STAFF REPORT
TBG ARCHITECTS
DRIVE-THROUGH FINANCIAL INSTITUTION / BANK BUILDING
SITE DESIGN REVIEW 4-22
JANUARY 18, 2023

Proposed Condition: Demolition of existing structure and construction of a 2,546 sf drive-through financial institution/bank building

SHEET
LA.1

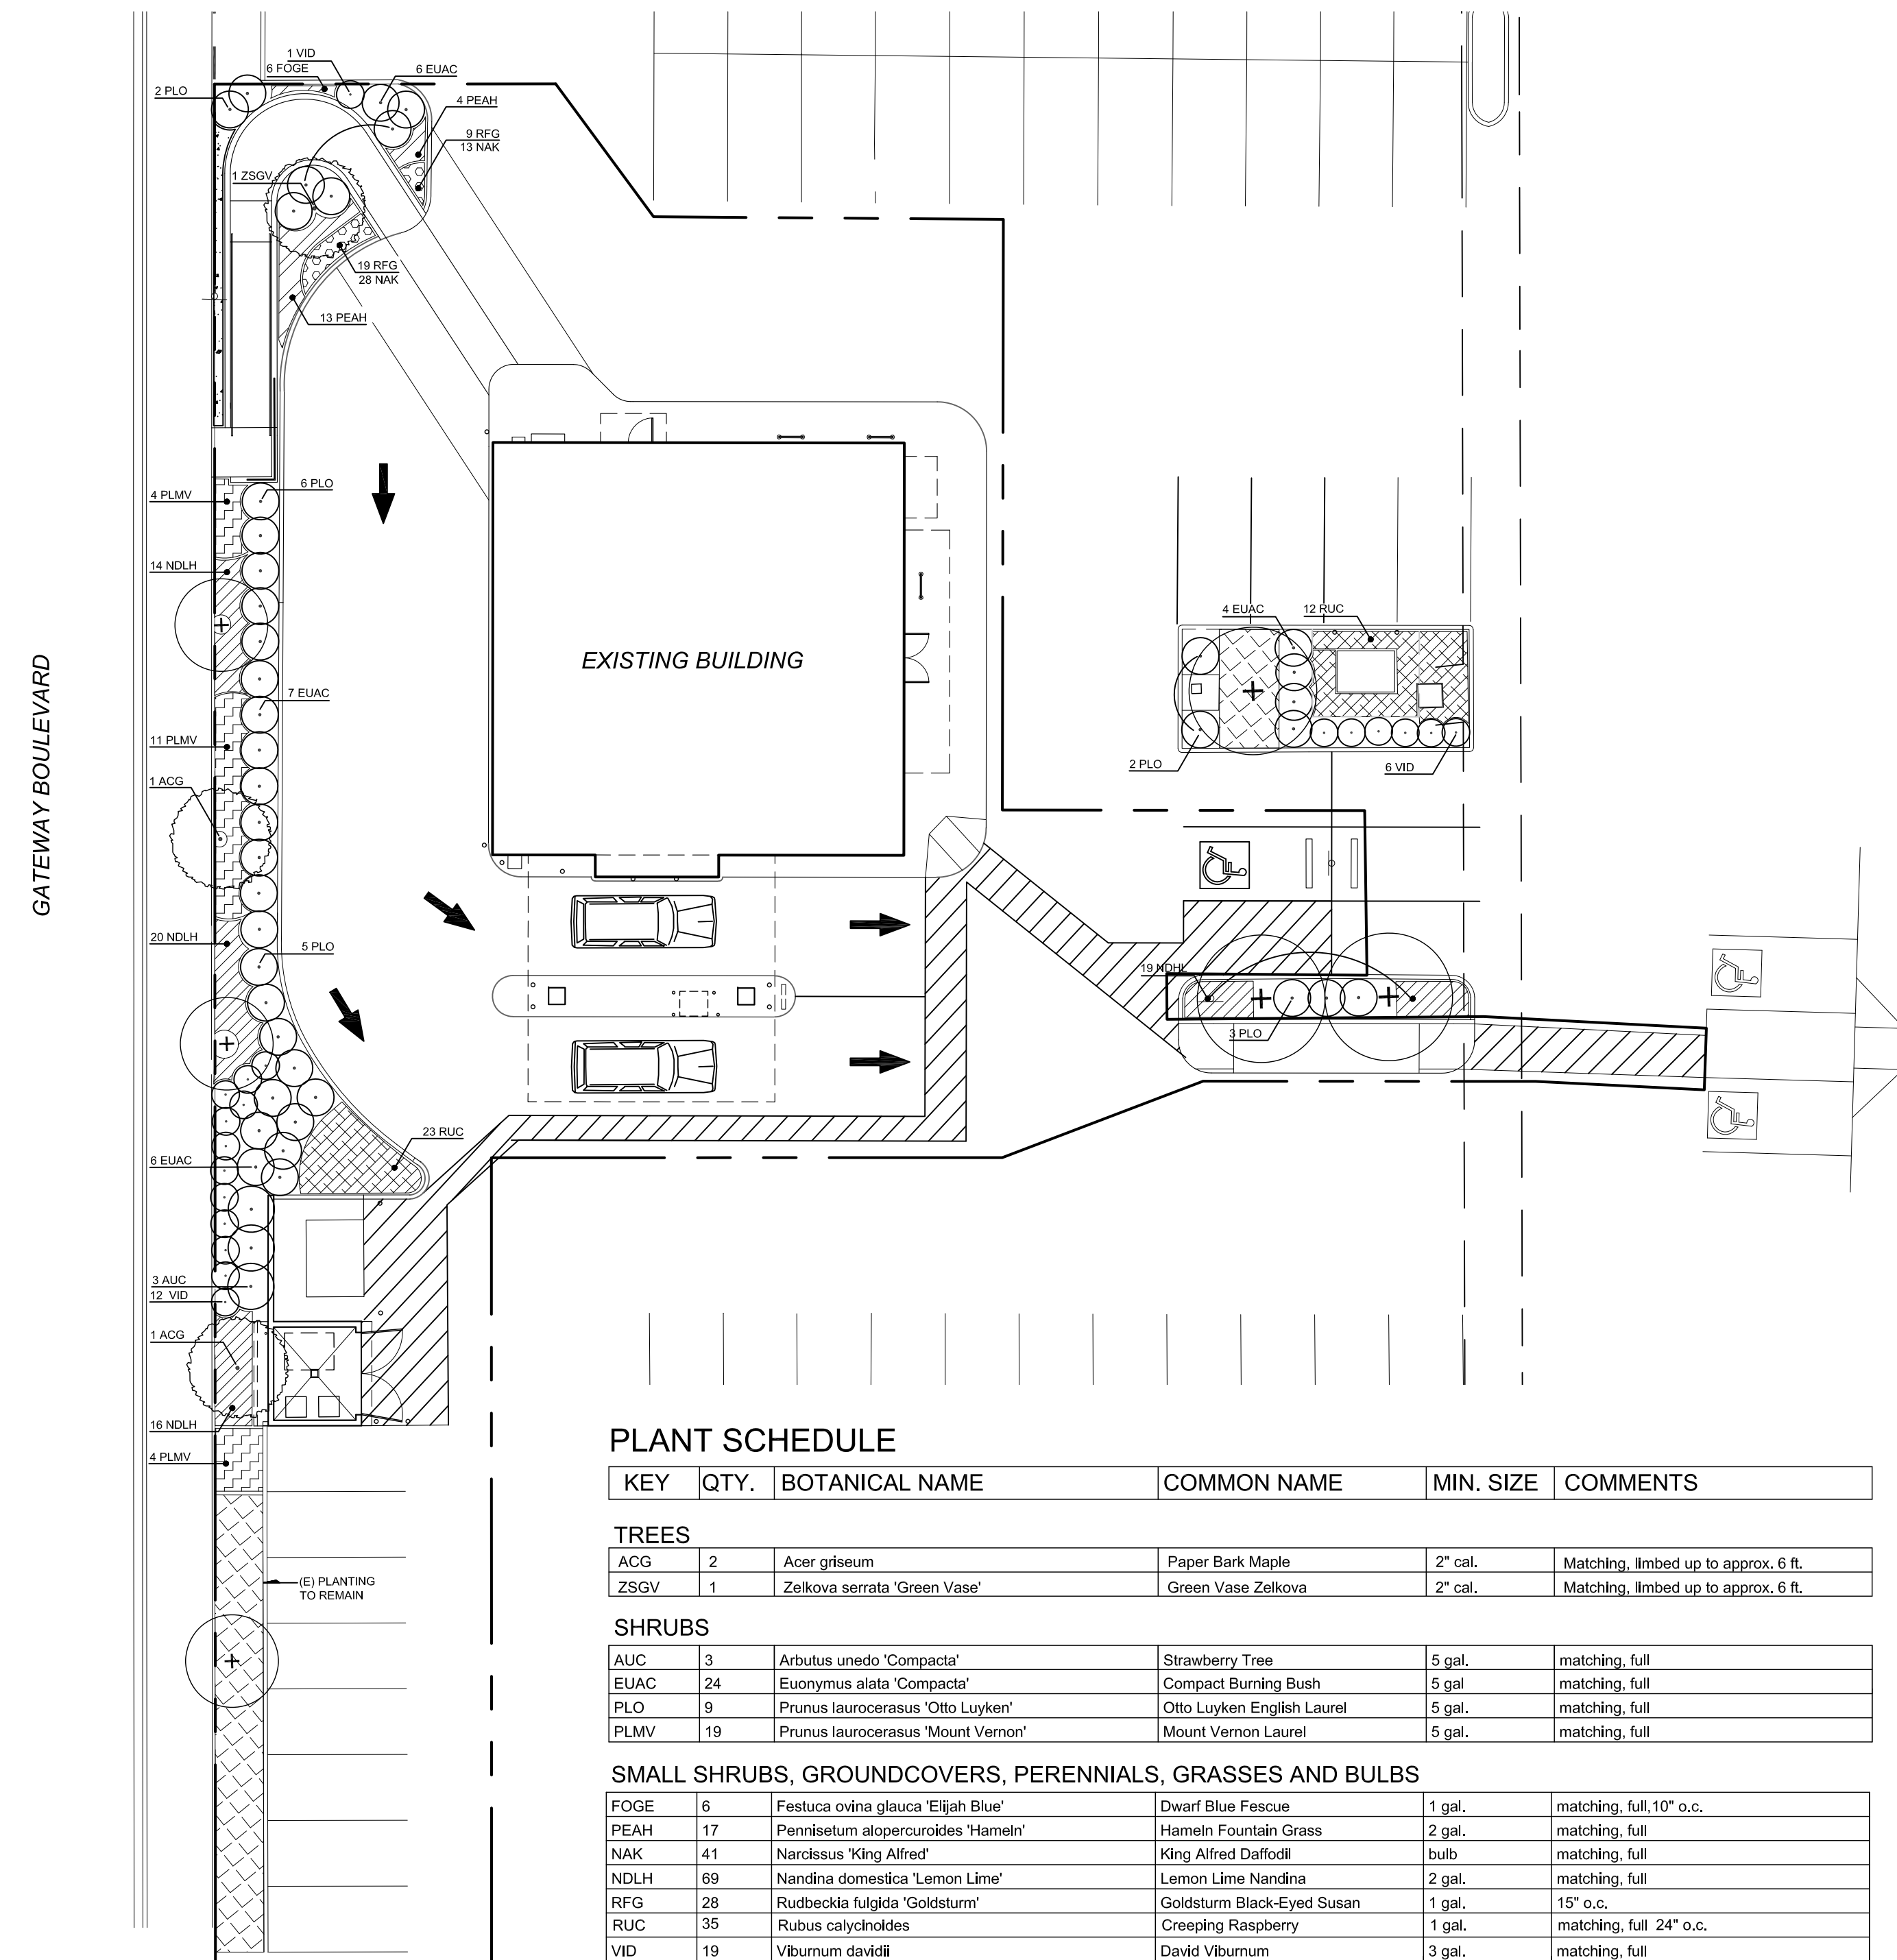
Staff response and findings of fact: The subject property's current landscaping consists of existing trees and ivy in the landscape bed along Gateway Boulevard. The applicant proposes the existing trees to remain, as well as add 3 more trees, while the ivy shall be replaced with ground cover plants as detailed on the submitted landscape plan. This criterion is met as proposed.

SITE PLAN

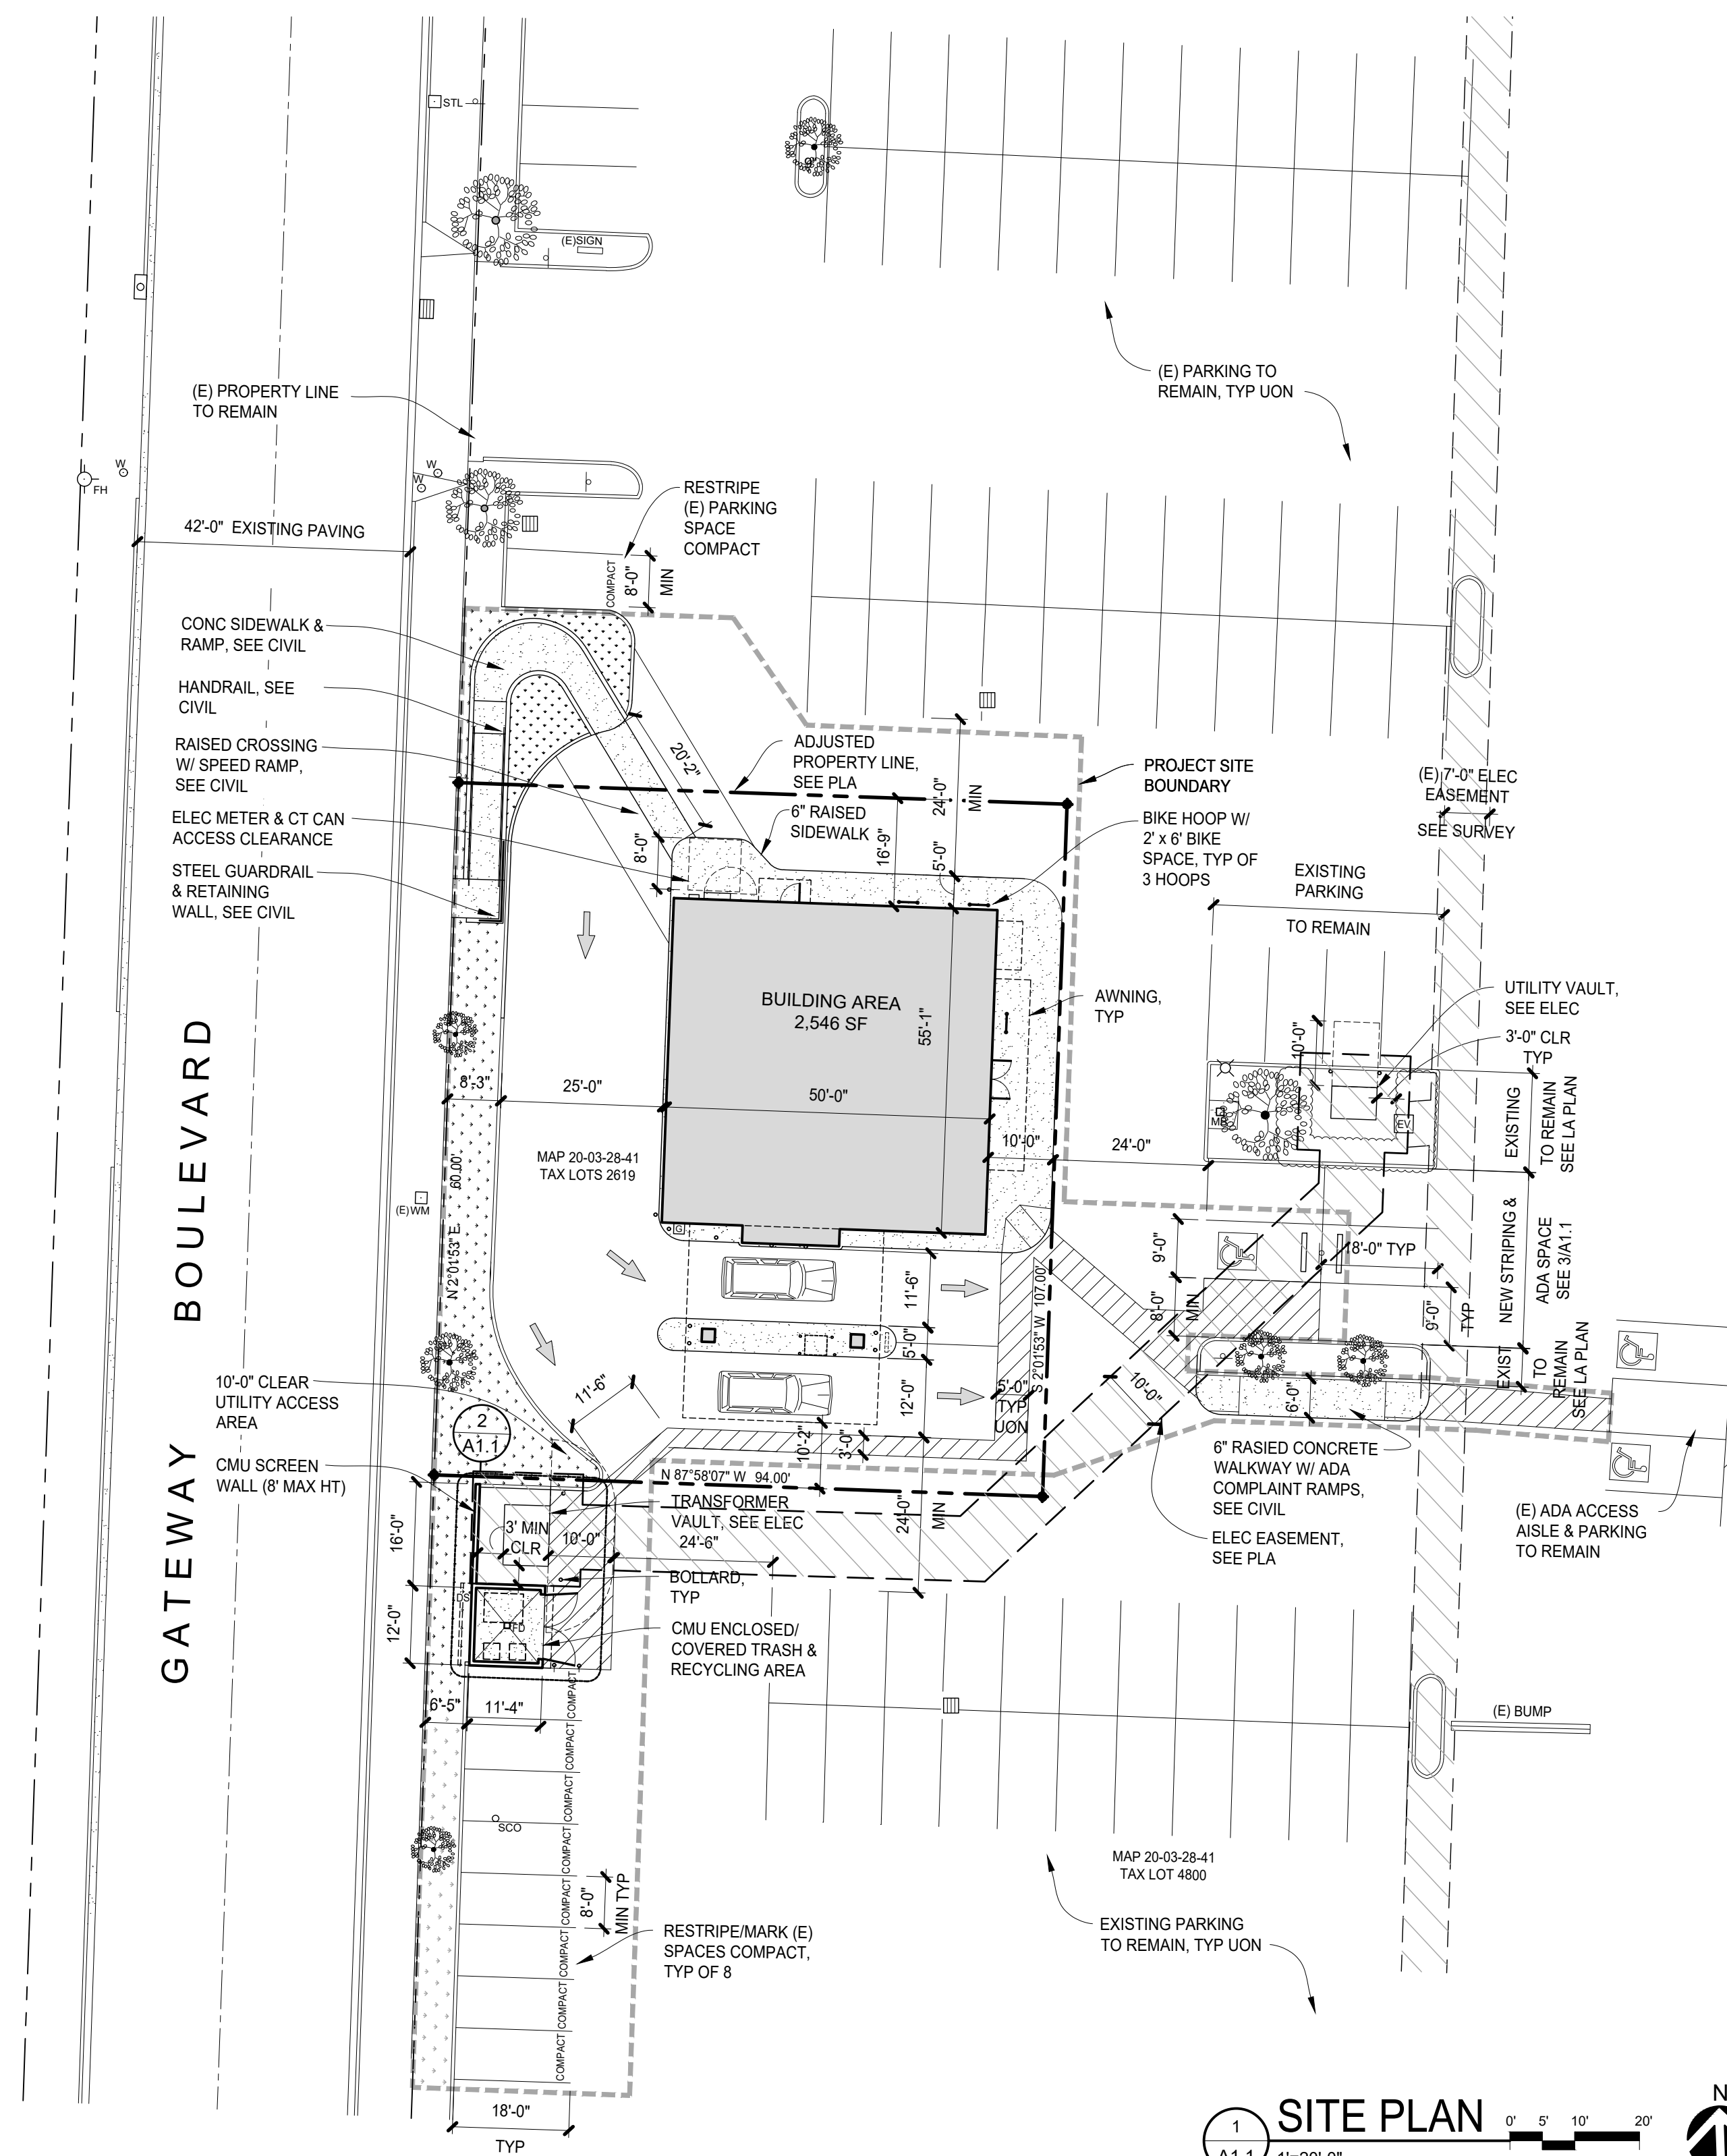
Staff response and findings of fact: As shown on the Site Plan, the proposed development provides a traffic circulation system that will accommodate traffic on site, and provides adequate pedestrian circulation through direct connections to the street side sidewalk along Gateway Boulevard. The proposed circulation design is the same as the existing structure with the additional drive-through lane to accommodate expected traffic. This criterion is met as proposed.

SHEET **A3.1**

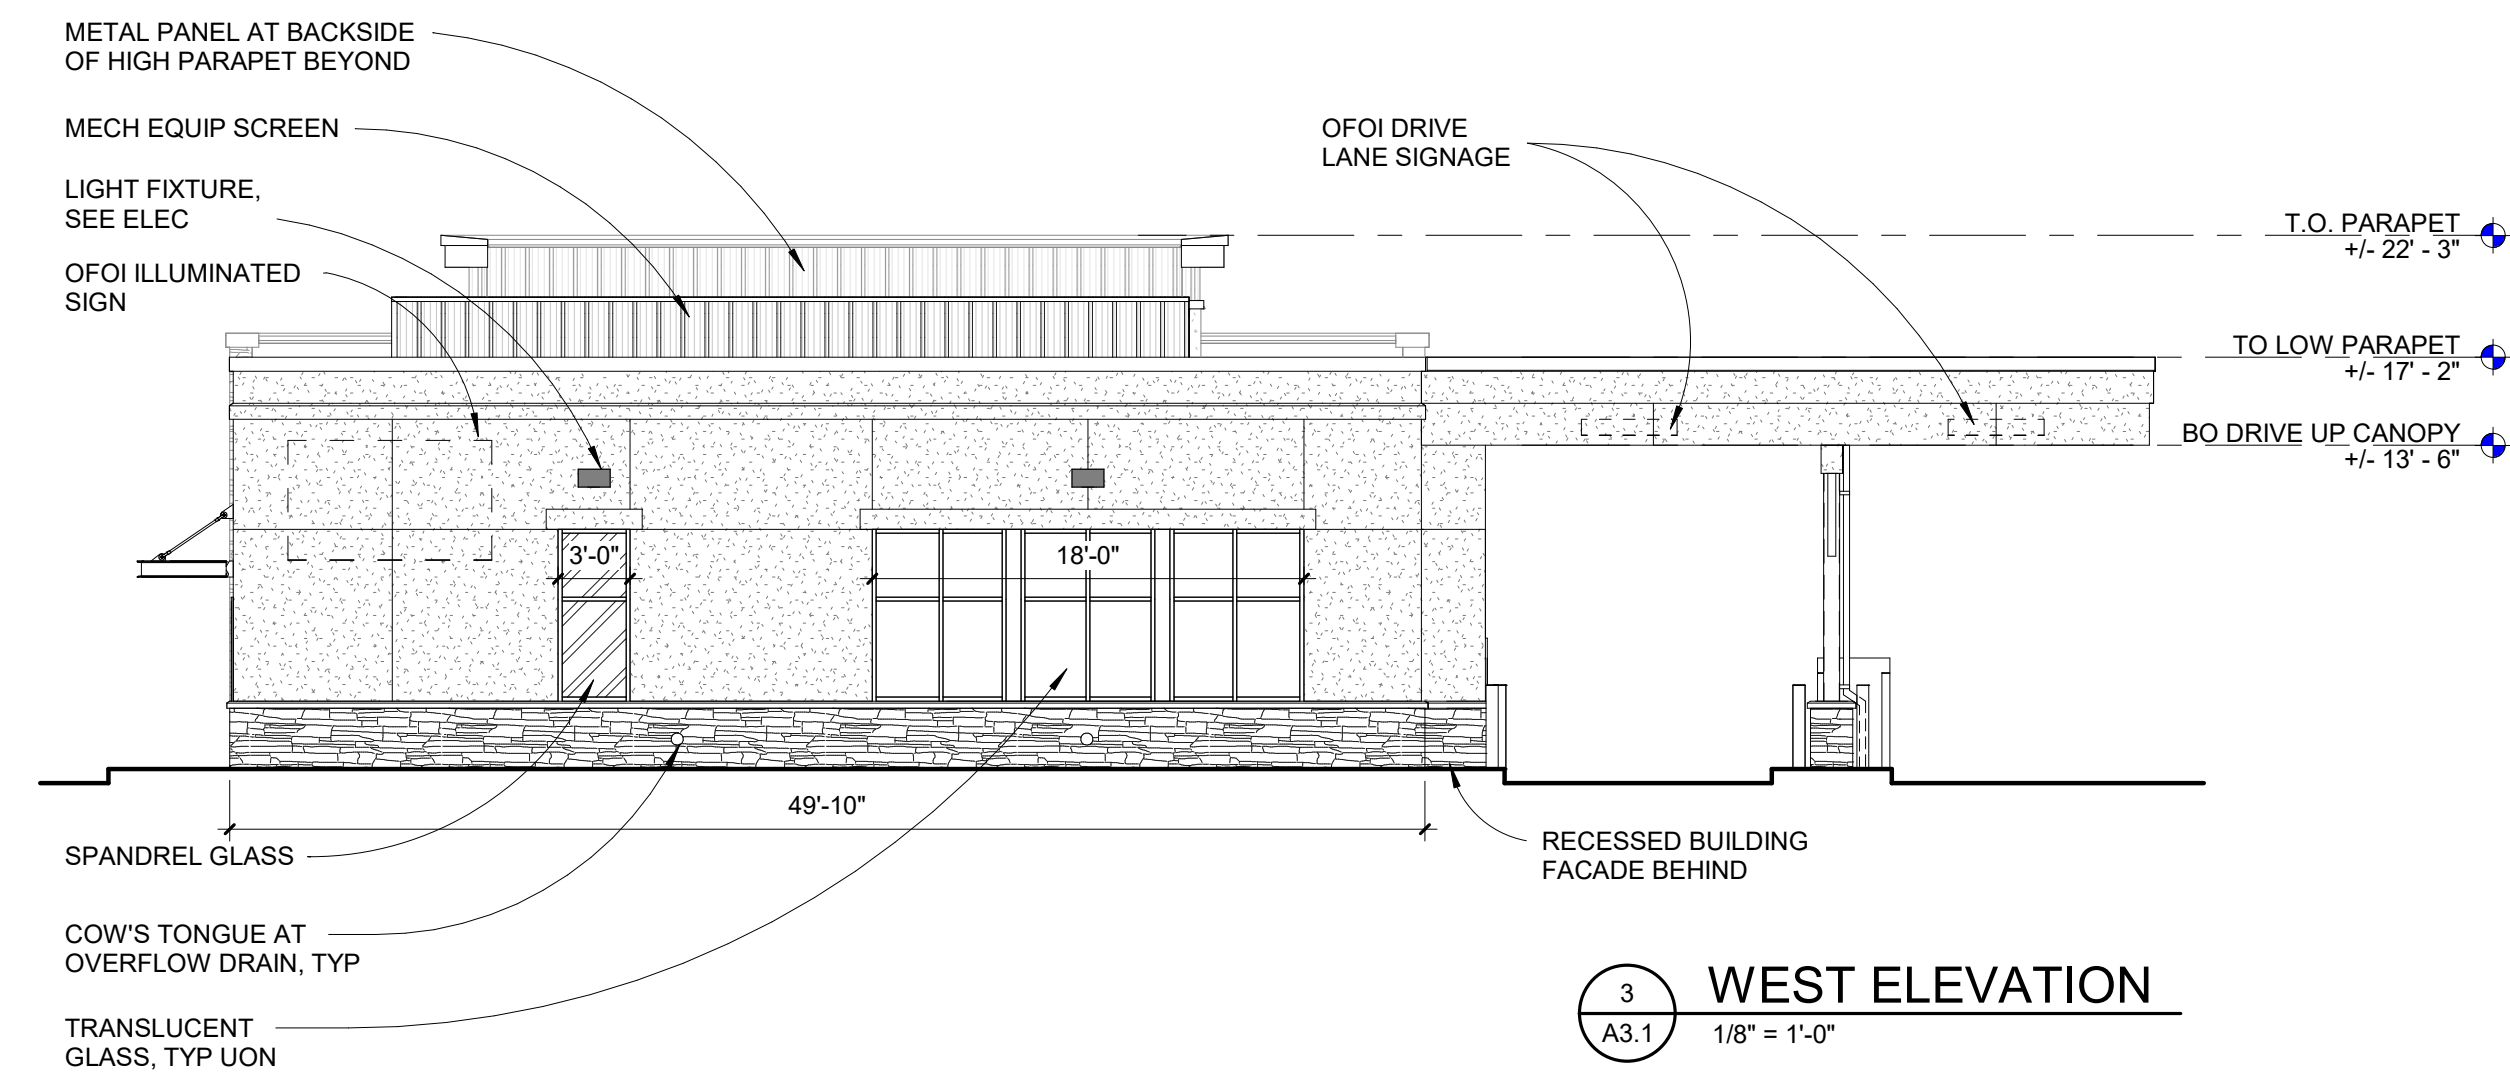
Staff response and findings of fact: The proposed structure has a total length of 49' 10" facing Gateway Boulevard, with a proposed 21 linear feet being covered by windows. This equates to about 42% of the street facing elevations being covered by windows, which are integral to the building design. This criterion is met as proposed.
